975 & 983 Pandora Avenue: Rezoning Application No.00683 and Development Permit with Variances Application No. 000543 (Downtown)

Development Permit with Variances Application No. 000543

Committee received a report dated April 29, 2021 from the Director of Sustainable Planning and Community Development regarding rezoning Application no. 00683 and Development Permit with Variances Application No. 000543 for 975 and 983 Pandora Avenue.

Figure 1: 1:5 setback ratio along Vancouver Street

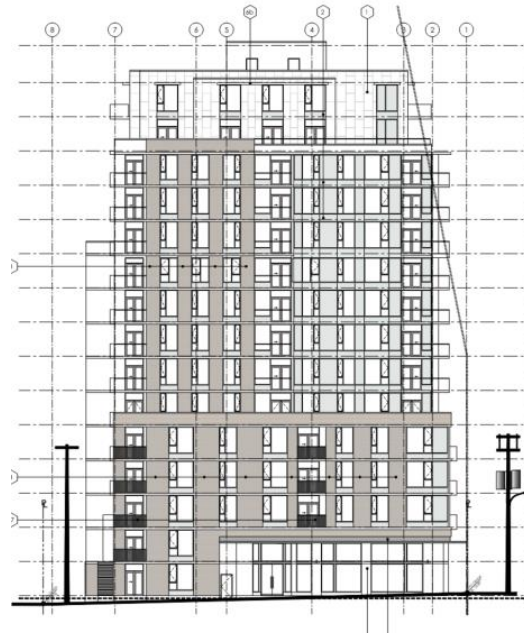
The upper storeys on levels 12, 13 and 15 encroach into the 1:5 building setback ratio along Vancouver Street as shown in Figure 1 below. However, staff consider these to be relatively minor in nature, since parapets, cornices, guardrails or other architectural elements are excluded. Similar minor encroachments exist for the Pandora Avenue frontage as shown in Figure 2.

15 DARK GREY HIGH QUALITY ALUMINUM PMT FENCE (WROUGHT IRON STYLE) Scale: 1:50

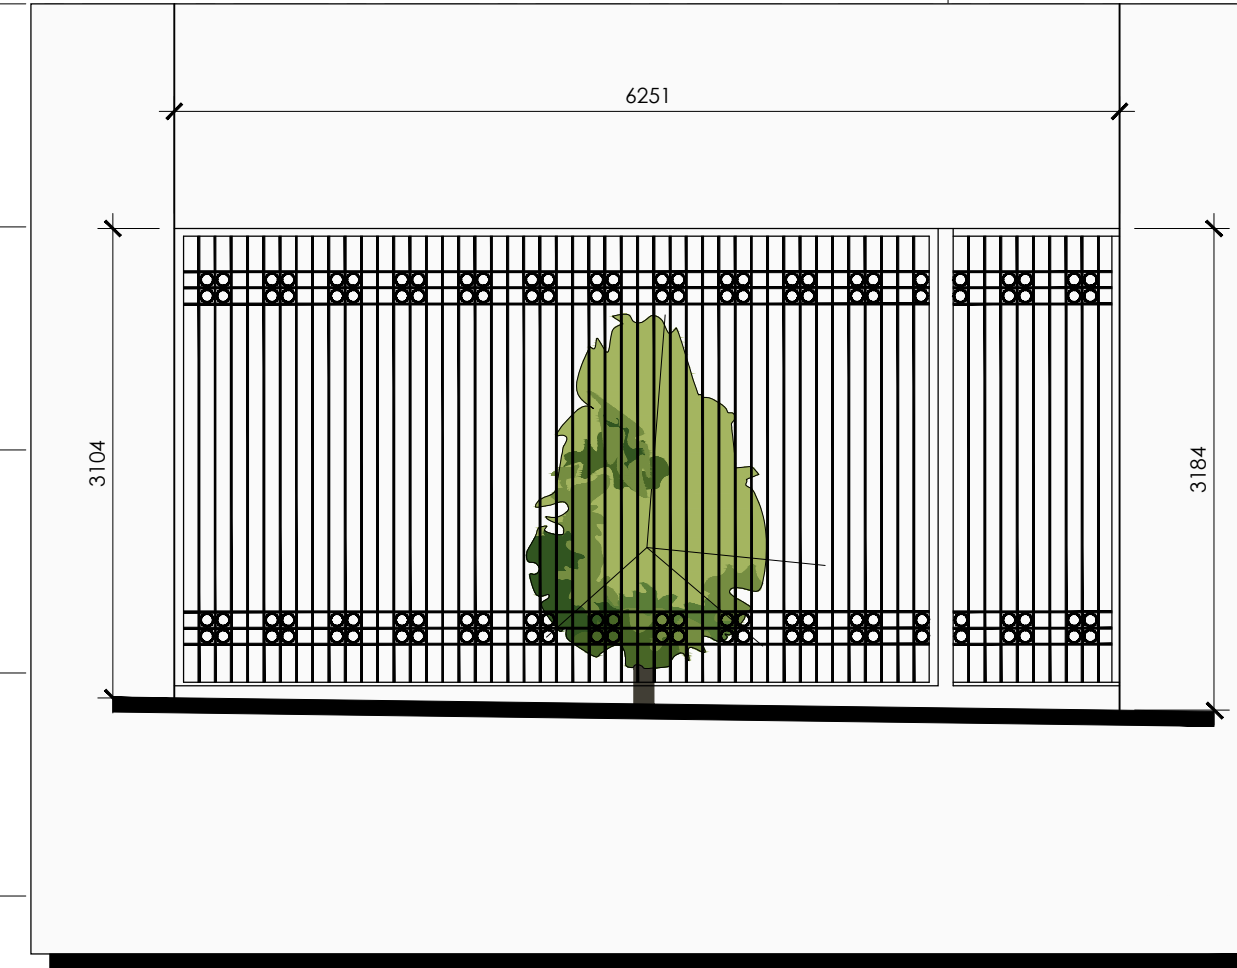
6. Provide greater detail of the PMT fencing. This should be a custom fence consistent with the breezeway design. Include detail on drawing A3-01.

Complete.

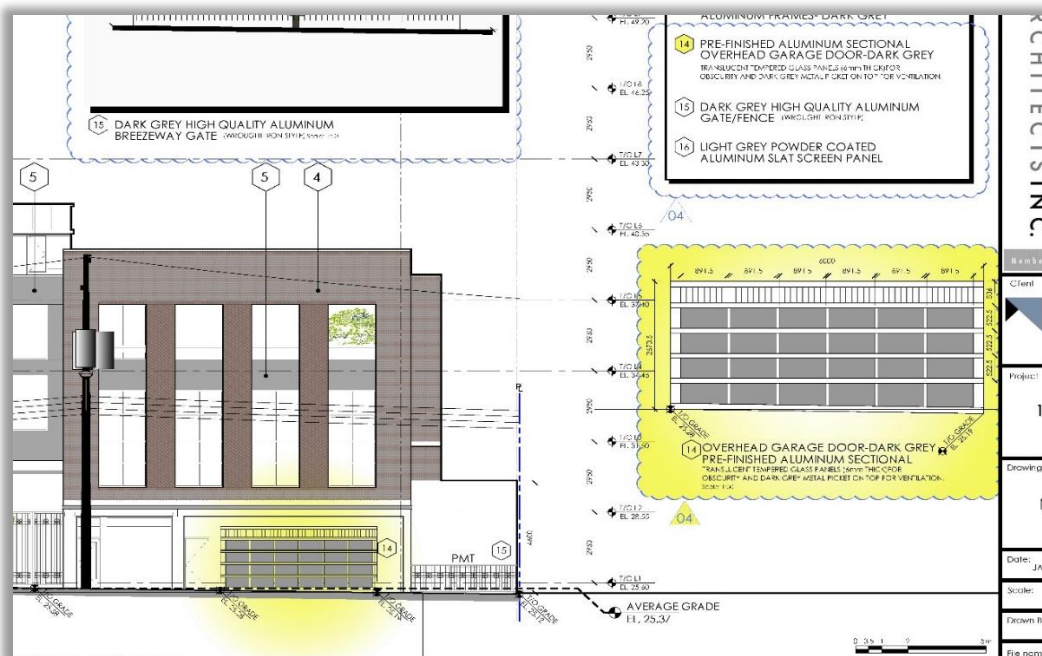
- Provide greater detail of the overhead garage door. A custom design is warranted since the garage door occupies a large portion of the frontage. Include detail on drawing A3-01.
[Complete.](#)

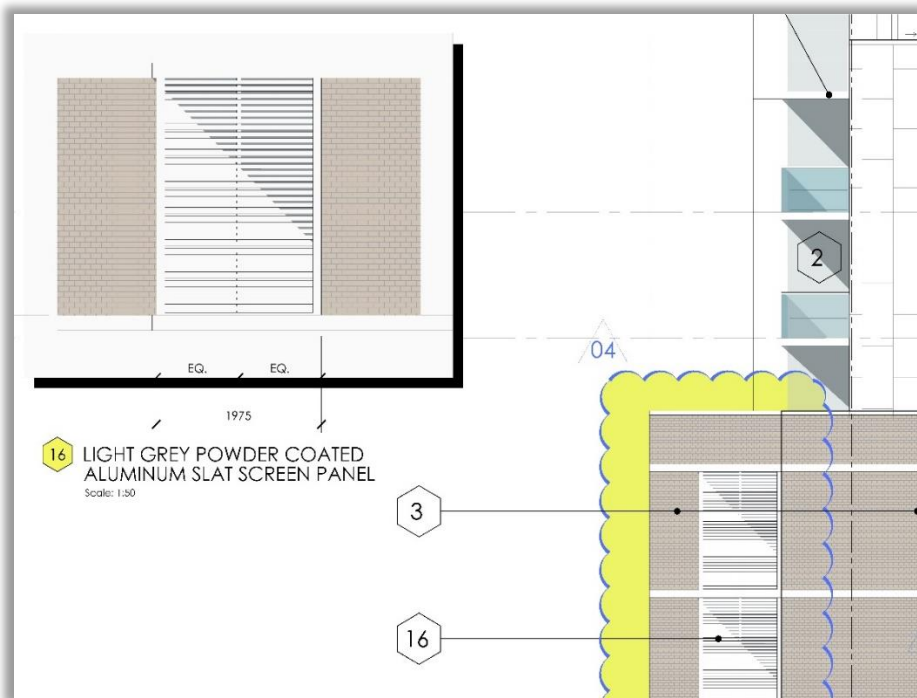
7. Label the material for the balcony screening on the south elevation and provide a blow up of this detail (include on the elevation drawing A3-02). Note the elevation doesn't match the 3D render for the lower brick portion of this elevation.

Complete.

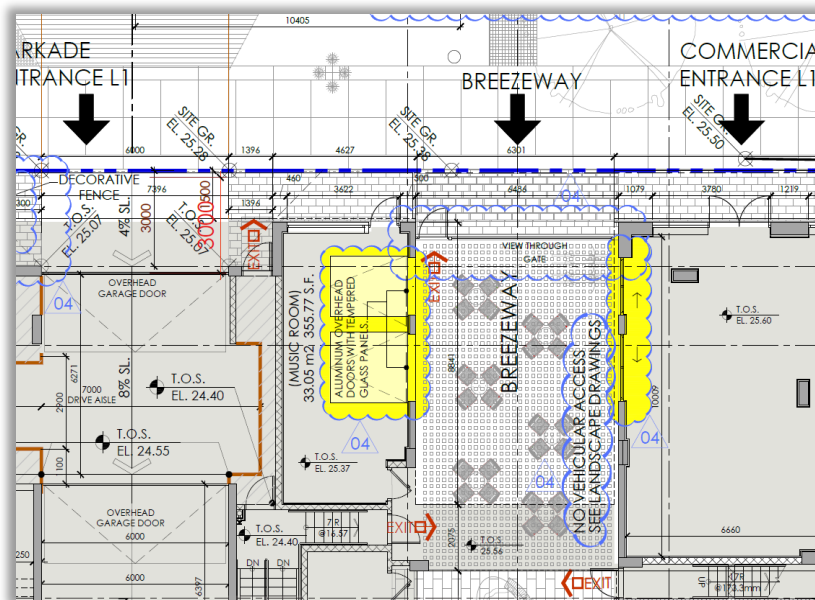
- Consideration of the relationship to the adjacent development to the south and the fenestration on the south elevation as it relates to the livability of units.

Bedroom windows in close proximity to the neighboring property have been changed to transom style for increased privacy and livability.
